METROPOLITAN AREA PLANNING
COMMISSION

Re: S/D 82-68 - Final plat of Chuzy Business Park.

Re: S/D 82-68 - Preliminary plat of Chuzy Business Park

REFERENCE Drainage Concept (Preliminary)

HYDROLOGY DATA SHEET

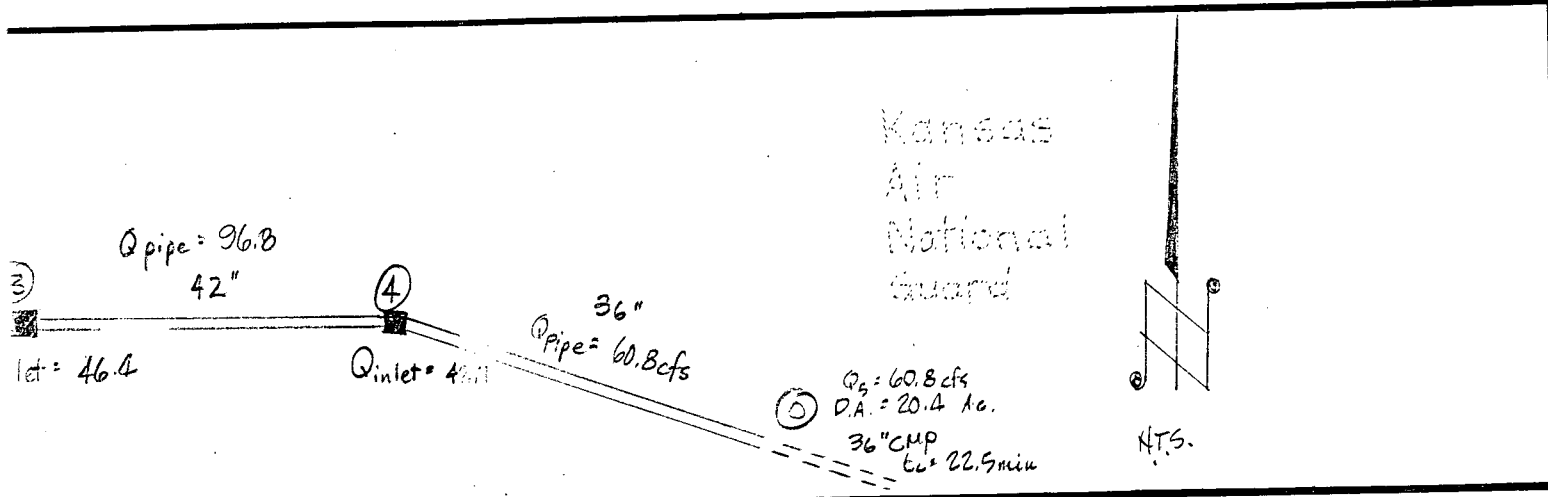
HYDROLOGY SUMMATION					CONDUIT DATA					
	T _c (minutes) (9)	I in./hr. (10)	Q (cfs) (11)	Σ Q (cfs) (12)	PIPE (inches) (13)	SLOPE (%) (14)	VELOCITY (ft./sec.) (15)	LENGTH (feet) (16)	T _f (minutes) (17)	T _c + T _f (minutes) (18)
3	22.5	4.45	60.8	60.8						
					0-4 36"	0.9	8.8	410	0.8	23.3
7	23.3	4.39	36.0	96.8						
					4-3 42"	1.0	10.5	440	0.7	24.0
4	24.0	4.34	38.7	135.5						
					3-2 48"	1.0	11.0	430	0.7	24.7
8	24.7	4.29	27.8	163.3						
					2-1 54"	0.9	10.5	430	0.7	25.4
9	25.4	4.24	25.2	188.5						
					1-EXIST Box 68" x 43"					
					USE ELLIPTICAL PIPE FOR BETTER CONNECTION TO EXISTING RCB

Item CULVERT STA 7100 SALINA DRIVE

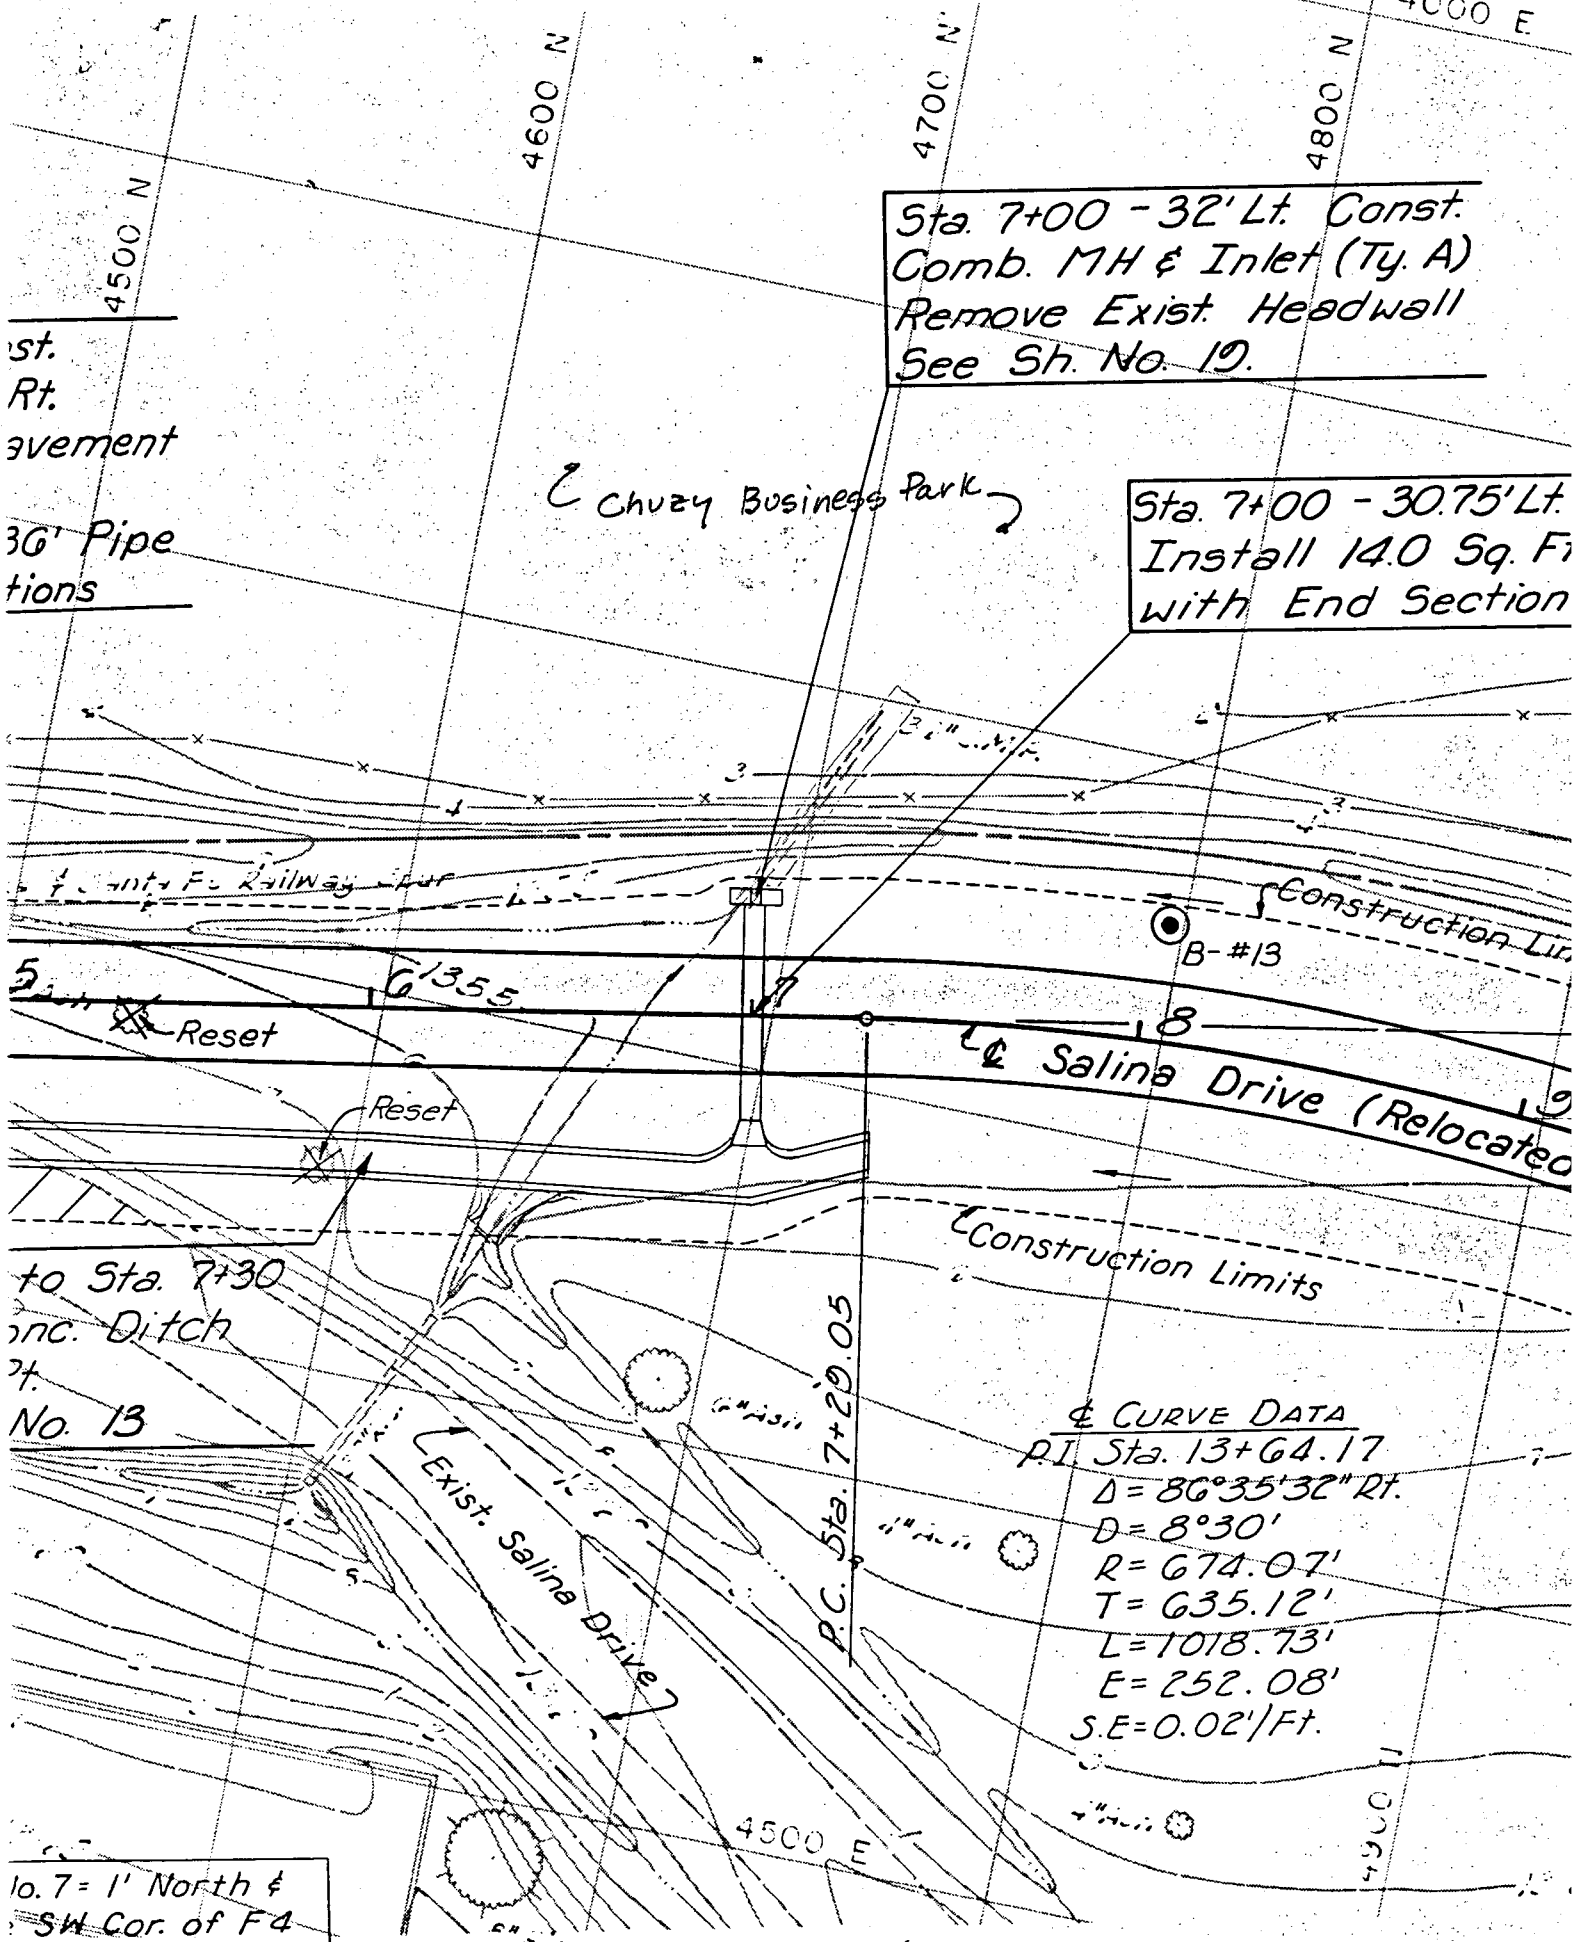
Plans call for 14.0 Sq Ft CRP, McPherson Conc. wants to know if 60x38" (12.5 Sq Ft) or 68x43 (16.5 Sq Ft) is acceptable.

KDOT Std calls for 68"x43" when "14.0 Sq. Ft." is called out.

Although WW Area is less, The 12.5 D' RCPHE is approx. equivalent to 14.3 D' CMMAC, in inlet control. The 60x38 will fit inside the ditch inlet easier, \therefore the 12.5 D' RCPHE should probably be allowed.
